RESIDENTIAL BUILDING PERMIT APPLICATION

Street Address: 12067 BROAD MEADOW LANE		Unit:
City: CLARKSVILLE	State: MD	Zip Code: 21029
Subdivision/Village/Complex Name: CLEARVIEW ESTATES		SDP/WP/BA #:
Lot: 41	Tax Map: 29	Parcel: 29-13
Grading Permit #:

Existing Use: SFD EXTERIOR DECK	Proposed Use: SFD EXTERIOR DECK	Estimated Cost: \$5,000.00
Trade Work to Be Completed (Separate Permits Required): <input type="checkbox"/> Mechanical (HVACR) <input type="checkbox"/> Electrical <input type="checkbox"/> Plumbing <input checked="" type="checkbox"/> None		
INSTALL 18' X 20' DECK ADDITION WITH STAIRS TO EXISTING DECK

LOCATION DRAWING
 12067 BROAD MEADOW LANE
 5th ELECTION DISTRICT
 HOWARD COUNTY, MARYLAND

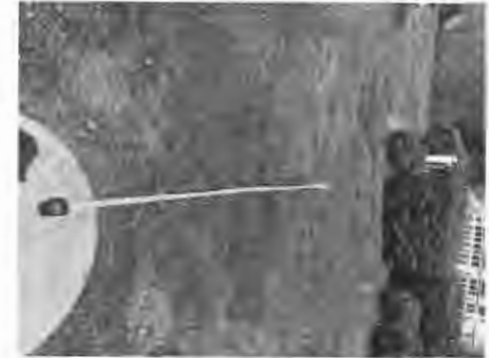
Here are photos showing tank location, tape is pulled from stake 15' from house at edge of proposed deck. edge of tank lid is 7'6" from deck.

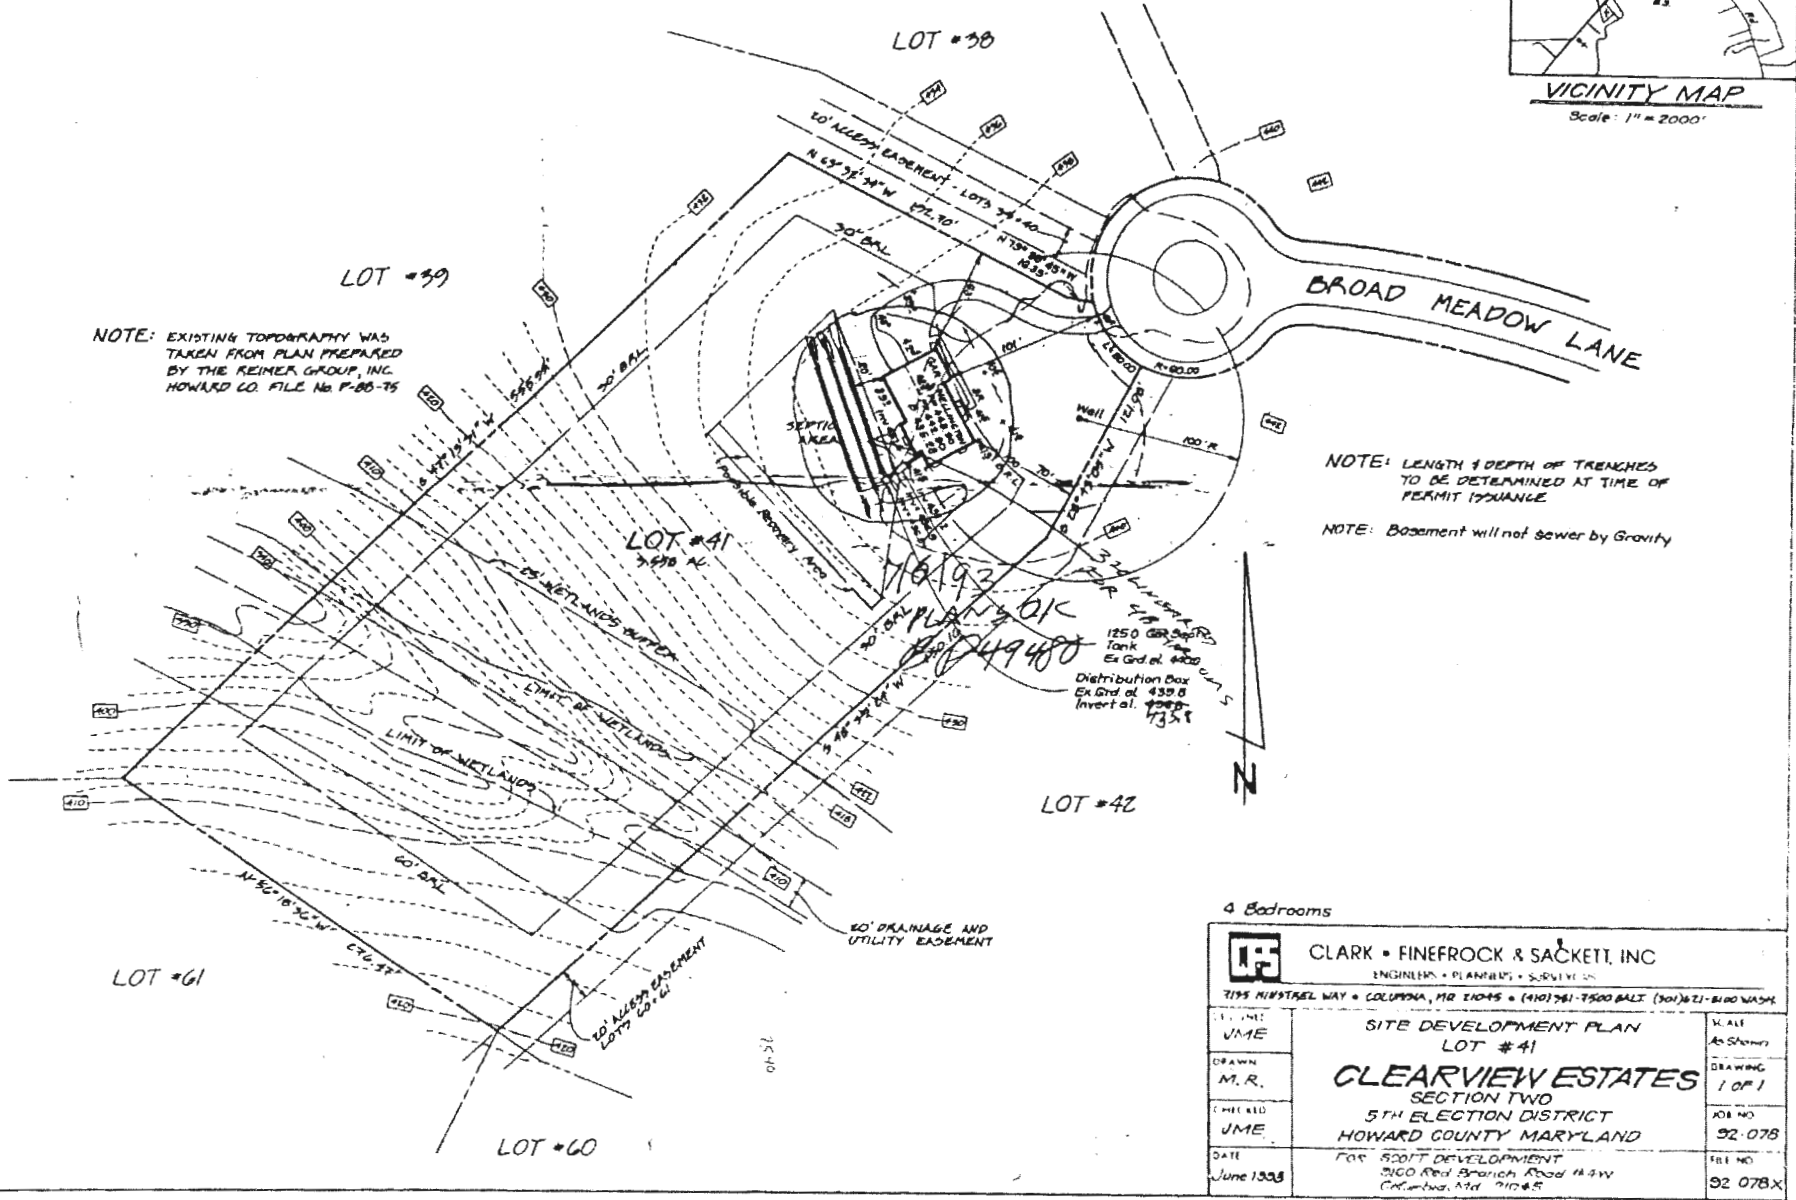
8/21/97 DECK PROPOSAL, SLIGHT REVISION
REQUIRED, MINIMAL CONSULT
ACCORDANT TO SEPTIC INSTALLATION
DIAGRAM, DISCUSSED W/ RICHARD
WELSHILL, ARCHITECT, REBID TO ERON
55, OK AT 1/6 FROM CLOSEST TRANCE TO
RIGHT CORNER OF DECK.
H
